FIELD ENGINEERING BILL-4520644 EC LEVEL- 857061 LOC-GREN

MACHINE TYPE-3614-001, 3614-002, 3614-011, 3614-012,

TITLE- INS FFBM VER 5 (DES DC9001) ON VER.3 MACHINES WITH TLA
FC 7820

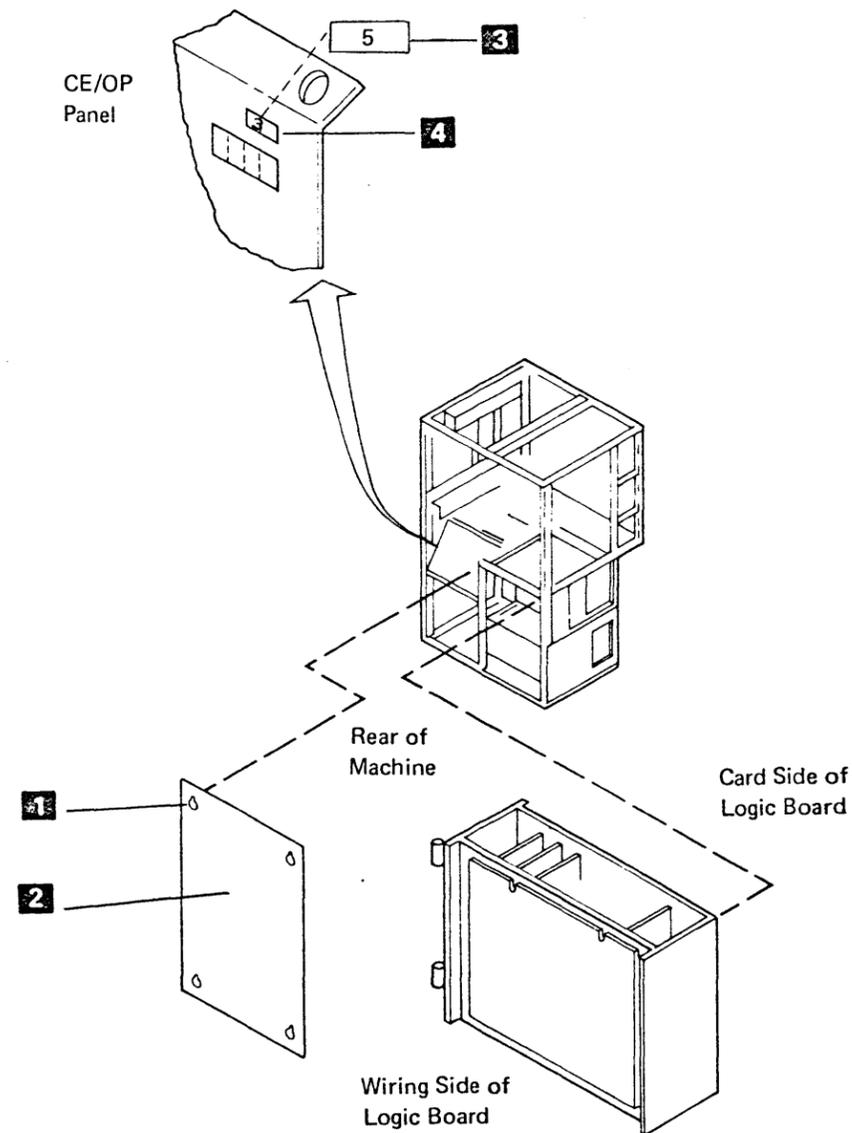
- __ 4. Remove Version 3 sticker **4** from upper right corner of CE/OP panel, above the display window.

- __ 5. Install Version 5 sticker **3** (P/N 5412746) onto upper right corner of CE/OP panel, above the display window.
- __ 6. Install the logic gate/power supply cover to the rear of the 3614 tightening screws loosened in step 10.1.3.
